SOUTHWEST CORRIDOR LIGHT RAIL PROJECT ALTERNATIVE

**City Council November 1, 2018 SW CORRIDOR TESTIMONY**  
**Good afternoon Mayor Wheeler and Council members.**

Re: City Council Agenda Item 1062 - Resolution concerning the Southwest Corridor Plan (SWC) Locally preferred Alternative (LPA)

RE: Southwest Corridor Plan DEIS & Initial Route Proposal Comments

Figure D-7

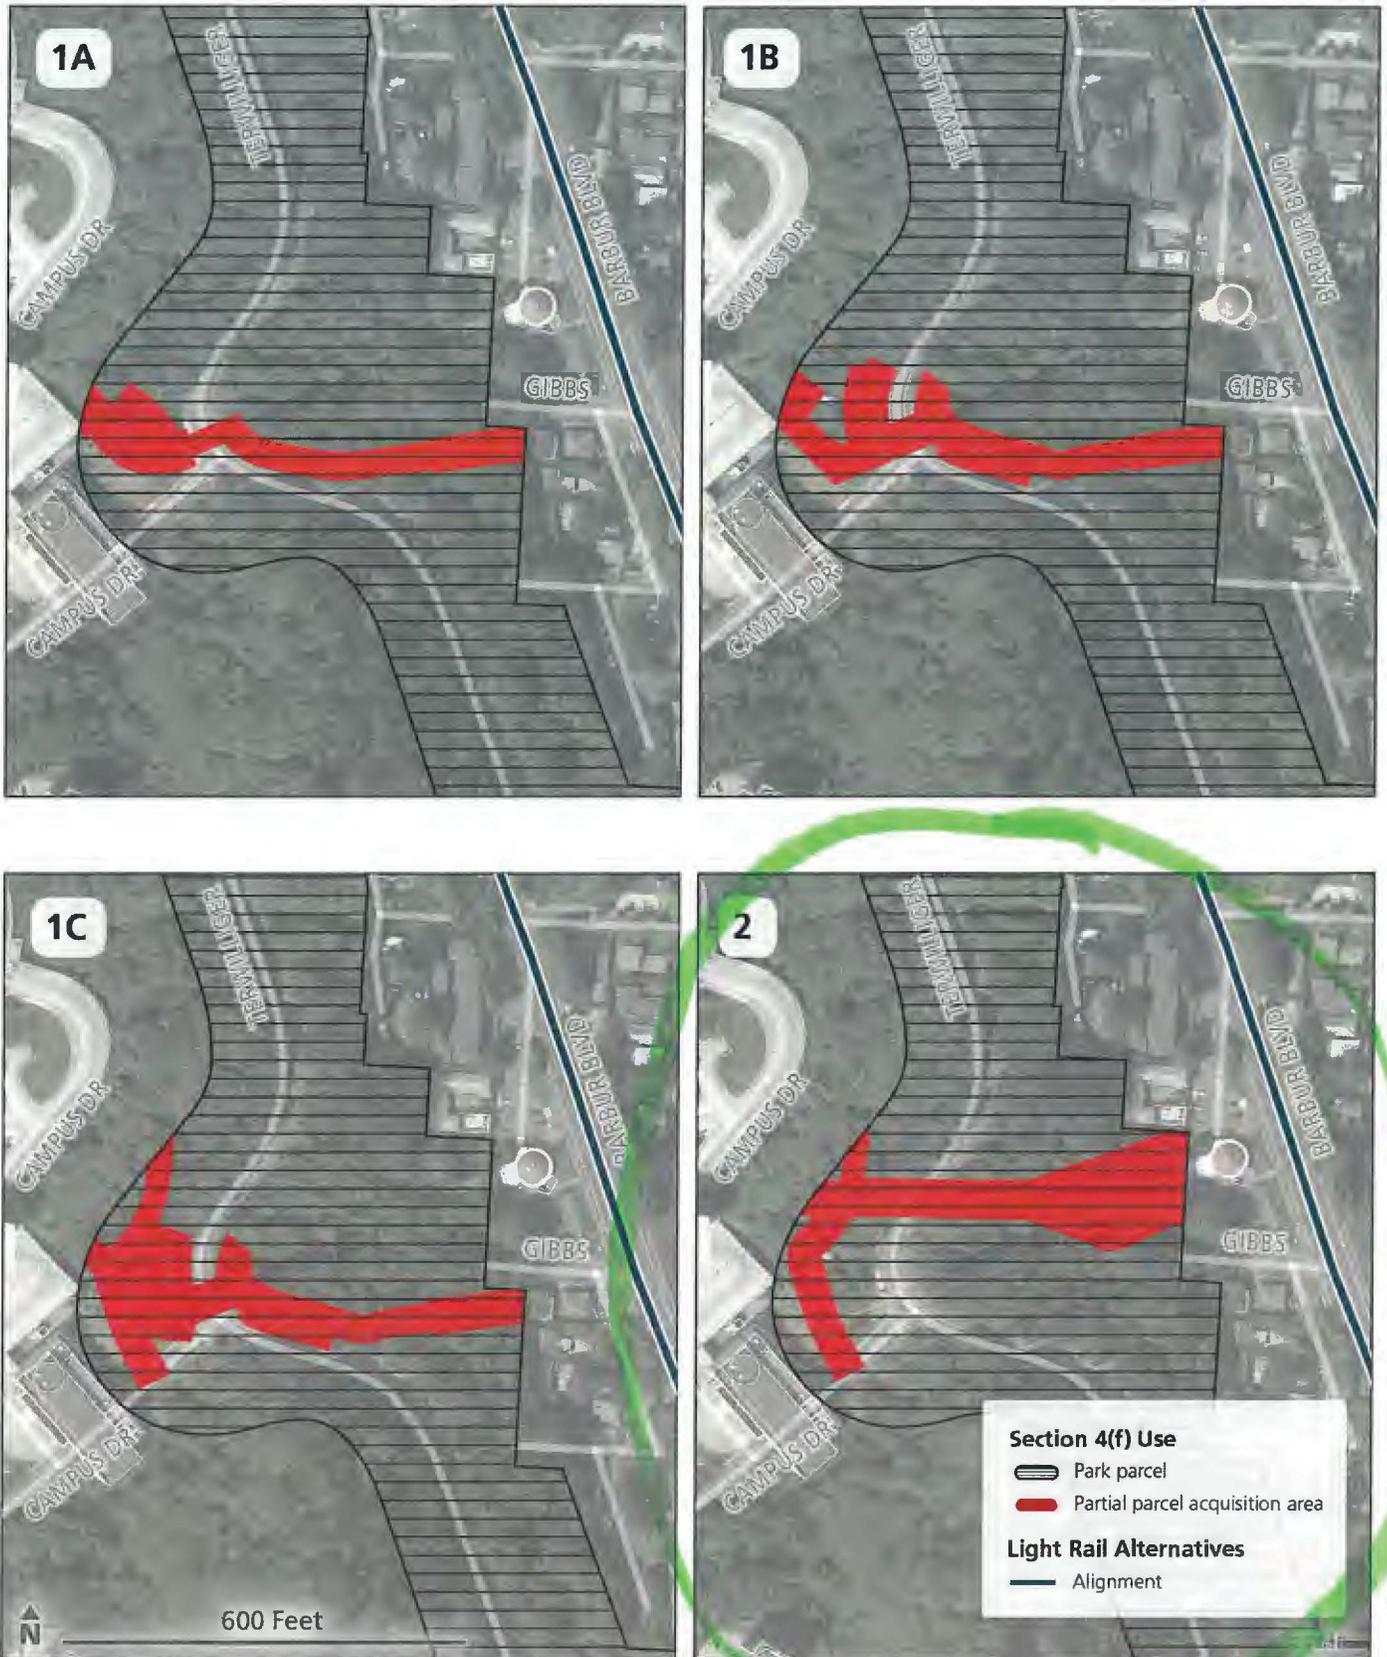
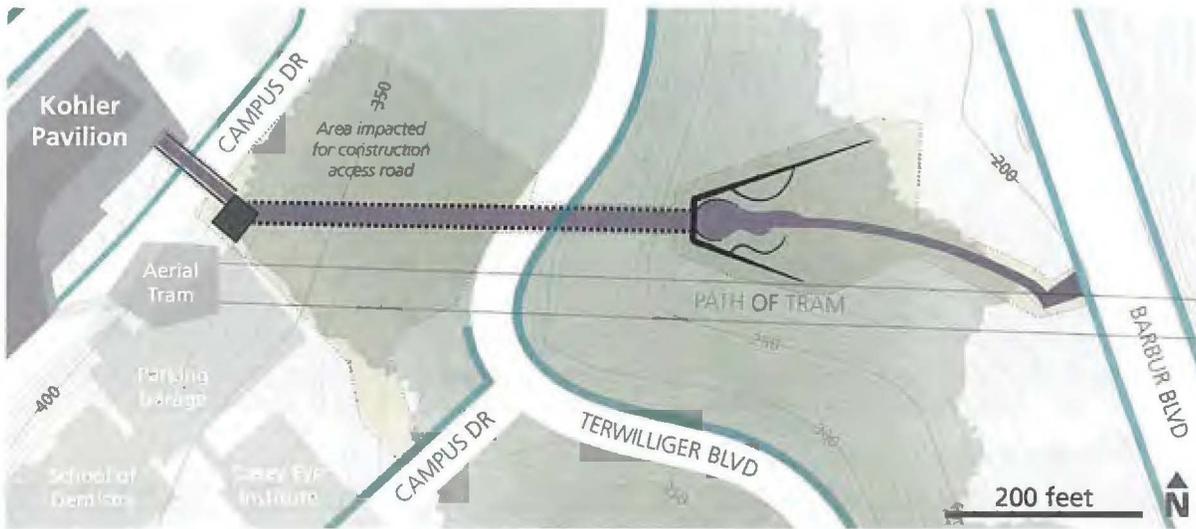
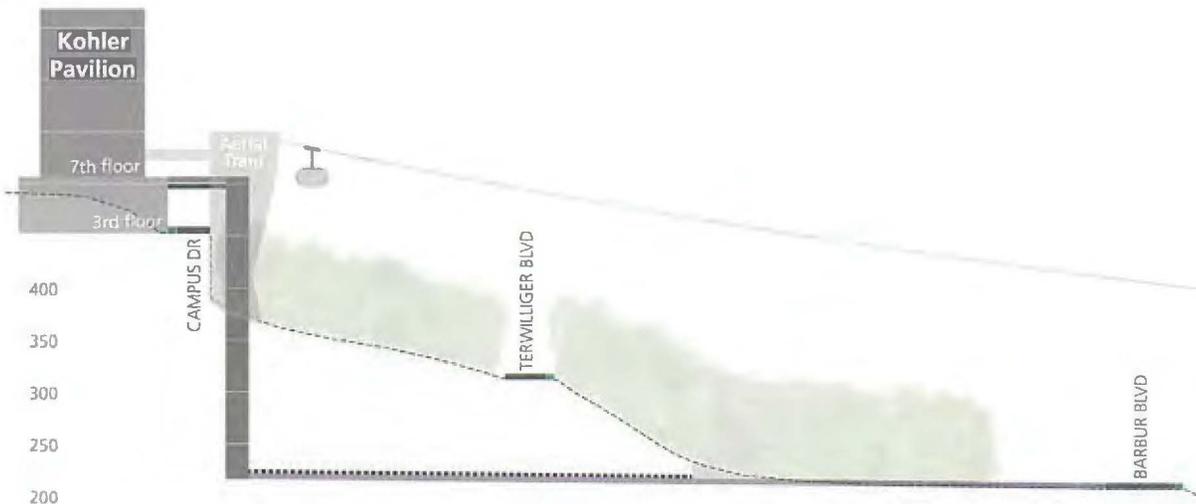
The other alternatives (1A, 1B, 1C) require removal of many of the trees that help define the desired "forested character" of the Terwilliger Parkway. These three alternatives include numerous structures (stairs, retaining walls, elevators, ramps and crossing signals) that are inappropriate and violate the cultural and historic values of the Terwilliger Parkway which were recognized by the City Council in 1983. Please note that when the Casey Eye Institute building was approved by the Portland Design Commission, the 150 foot setback from Terwilliger was required to be replanted with trees appropriate for the "forested Setting" of Terwilliger Parkway. Many of these same trees would need to be sacrificed to accommodate these other alternatives.

All of the connection options violate the Terwilliger Parkway Corridor Plan in several ways. Please refer to Friends of Terwilliger's comments on the DEIS for a detailed analysis (included here.)

According to the discussion of Section 4(f) Resources in Appendix D, the impacts to Terwilliger Parkway of all the Marquam Hill Connection options are significant: *“The impacts to Terwilliger Parkway from the vegetation removal and ground disturbance will be long lasting and will result in a severe visual change to this park. These impacts cannot be mitigated down to de minimis, and the Marquam Hill connection is therefore assumed to be a permanent use regardless of the option selected.”* In spite of this evaluation, the Connection options have moved forward and no alternatives that don’t significantly impact the parkway have been adequately studied. As the record will show, Friends of Terwilliger testified or provided comment on several occasions and implored project staff and leaders to find a LRT connection that does no harm to Terwilliger Parkway, but it appears we have been ignored.

All four of the connection options violate one or more of these goals and, as stated in the 4(f) evaluation, will have *"long lasting impacts"* that *"will result in severe visual change"* and that *"cannot be mitigated"*.

Figure 1. Tectonic setting of major earthquake threats in metropolitan Portland (DOGAMI, 2018).

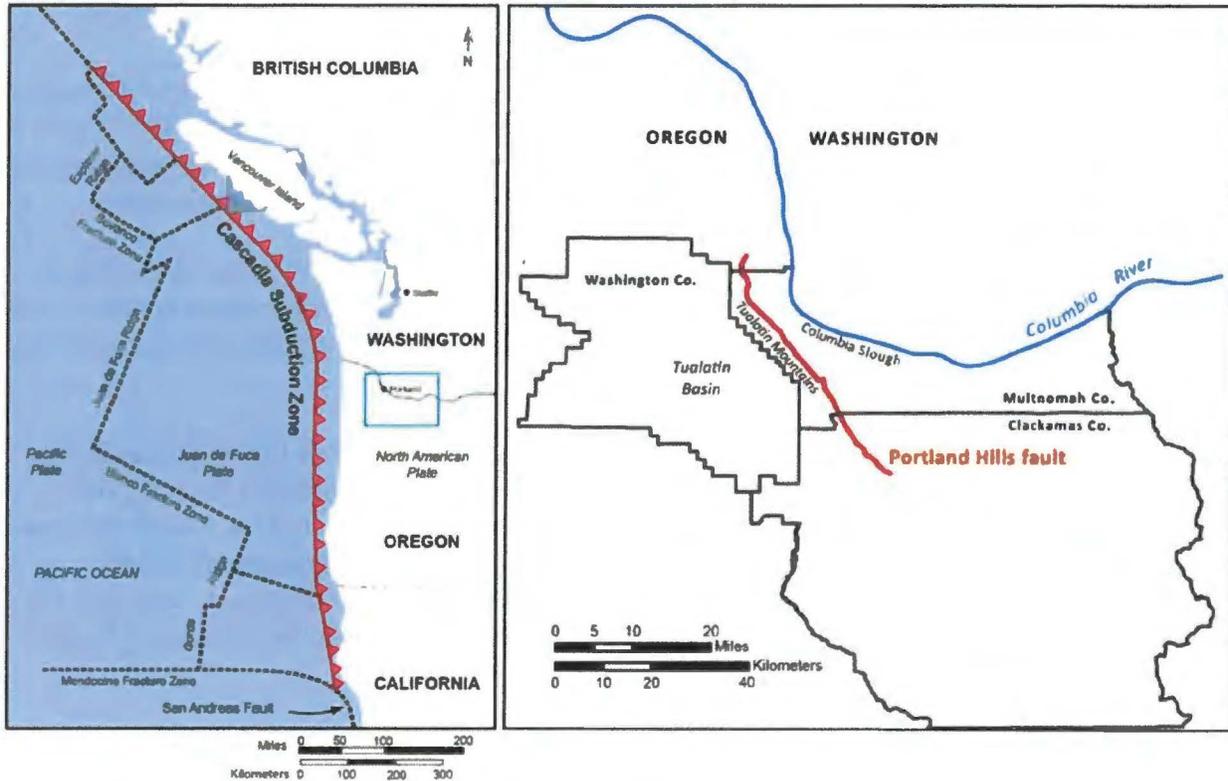
Metropolitan Portland eventually will experience major earthquakes from 2 tectonic sources (see Figure 1): M9.0 events in the Cascadia Subduction Zone offshore of the Oregon and Washington coasts and equally, if not more, damaging M6.8 events in the Portland Hills fault complex that directly underlies the inner two-thirds of the Project corridor. Multiple recent studies from DOGAMI and the Oregon Seismic Safety Policy Advisory Commission (OSSPAC) have begun to (a) inventory critical infrastructure that is vulnerable in a major earthquakes event and (b) propose earthquake resilience strategies for seismic upgrades of critical infrastructure. Unfortunately, none of these studies has specifically addressed risks to highway bridges in metropolitan Portland.

Whether intentionally or by coincidence, Design Refinements #1, 2 and 4 allow Metro and TriMet to sidestep responsibility for advancing regional earthquake resilience objectives. In a climate of perennial financial constraints for public projects, earthquake resilience can be achieved only by aggressively leveraging investments in public works projects whose primary purposes may be unrelated to the mitigation of earthquake risk. In this respect, opportunism is an essential element of earthquake resilience policy: the best time to make seismic upgrades is when age or modification for a new use justifies replacement or major reconstruction of a facility. Effectively, every major transportation project in metropolitan Portland must be, in part, an earthquake resilience project.

The Draft EIS treatment of earthquake hazards is wholly inadequate. Issues it should address include:
